**CITY PLANNING COMMISSION**  
1231 "I" STREET, SUITE 200, SACRAMENTO, CA 95814

**LOCATION:** 1039 11th Ave.

**PROPOSAL:** The applicant is seeking the necessary entitlements to construct a single family residence.

**APPLC. NO.** P90-473

**EXHIBIT - A  
SITE PLAN**

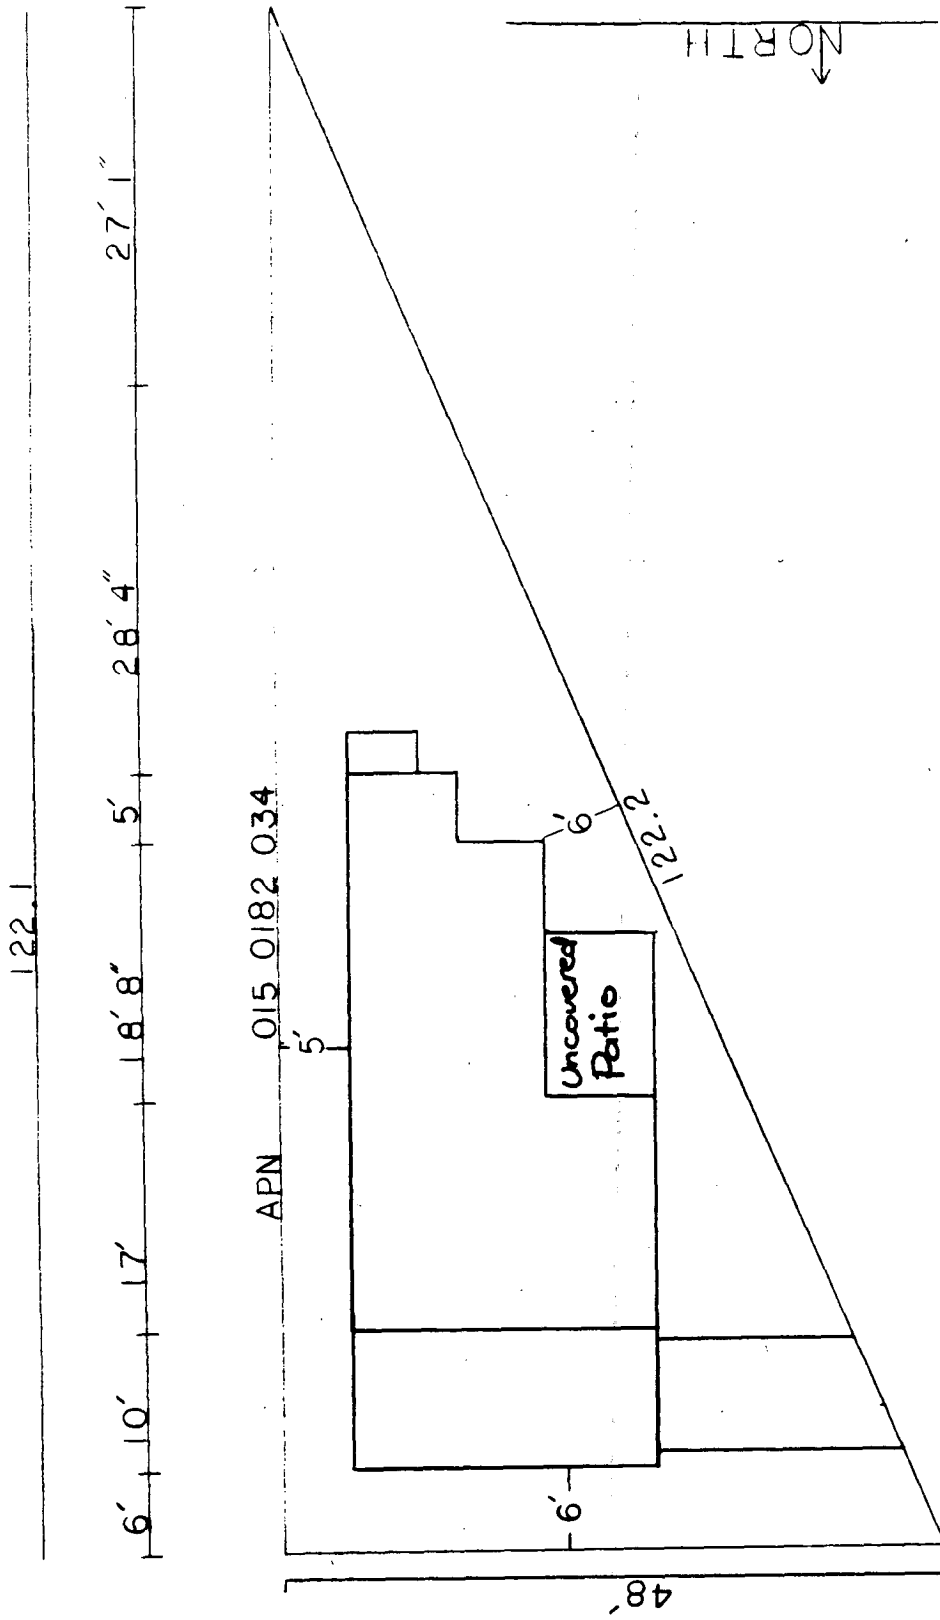
The proposed single family residence would be situated on a triangular lot measuring 48' x 102'1" x 122'3". The lot is at the corner of two unimproved alleys. The proposed driveway to the residence would come off the alley connecting 10th and 11th Avenues. The driveway would measure 14 feet from the shortest point, 18 feet from the longest point, and 16 feet from the midpoint in the driveway. The Zoning Ordinance requires a 20 foot driveway. Staff has no objection to the shorter driveway in this case since it is off of an alley where there are no pedestrian sidewalks nor pedestrians. The residents of the single family units facing Stockton Boulevard use the north-south alley as access to their homes. Several of the garages in the vicinity are situated next to the alley and other garages off the alleys have driveways less than 20 feet deep.

The rearyard area would be reduced to 6 feet from the required 15 feet. The front yard setback is up to 52' from a distance equal to the front of the house to where the lot comes to a point. The shortest front setback distance is 27'. Due to the odd shape of the lot and because the proposed residence would cover 38% of the lot, staff has no objection to the intrusion of the house on the required rearyard setback area. Adequate open space area for occupants of the proposed residence and adequate setbacks from neighboring residential units will be provided. Adequate access to the house will also be provided from the two adjacent alleys.

The applicant has not shown landscaping features or a fence design. The applicant should submit a landscaping plan and a fence design to be approved by the Planning Director.

The project was reviewed by the Engineering Development and Traffic Engineering Divisions. There was concern expressed over the driveway depth. The Traffic Engineer, as general policy, is not in favor of providing a

driveway depth of less than 20 feet. As previously mentioned, staff does not have a concern over the proposed driveway depth in this instance.

- 2. The applicant shall submit landscaping, fence, and revised building plans subject Planning and Design Review staff approval before issuance of a building permit. The plans shall contain the following features:

**EXHIBIT - B**  
**ELEVATIONS**

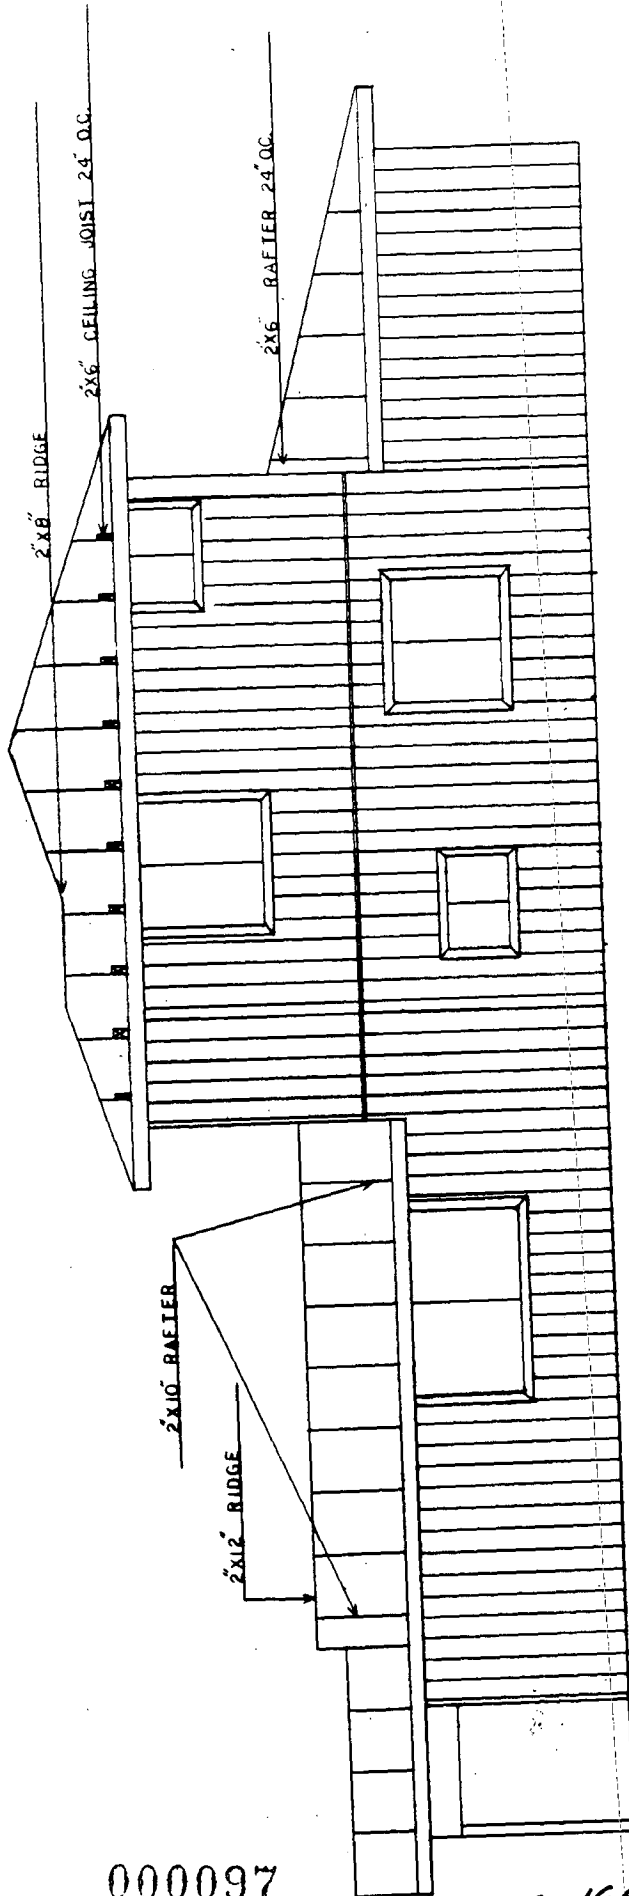
The building materials consists of T1-11 exterior siding and laminated composition shingles on the roof. The exterior building color is proposed to be a dark gray. The proposed building would be a split level. The first floor would contain approximately 721 sq. ft. and the upper floor would contain approximately 394 sq. ft. The upper story would be situated approximately midway over the first story portion. Staff has concerns regarding the design of the structure. The design improvements should contain, but not be limited to, the following features: The siding of the house should have accent trimming where the T1-11 panels come together and around the doors and windows. Stucco with wood trim would be a better choice. The roof should be redesigned with slanting ends to match the angle of the higher roof. There should be corbels (ornamental roof supports) at various locations. The windows and sliding glass door onto the patio should have gridded panes. The doors and garage door should have panels. The roof should be covered with laminated composition shingles.

- a. The siding shall be of stucco or the T1-11 shall have accent trimming where the T1-11 panels come together and around the doors and windows.
  - b. The roof shall be designed with slanted ends to match the angle of the higher roof.

- c. Corbels shall be placed at various locations according to staff recommendation.
  - d. The windows and sliding glass door onto the patio shall have gridded panes.

- e. The doors and garage door shall have panels.

- f. The roof shall be covered with laminated composition shingles.
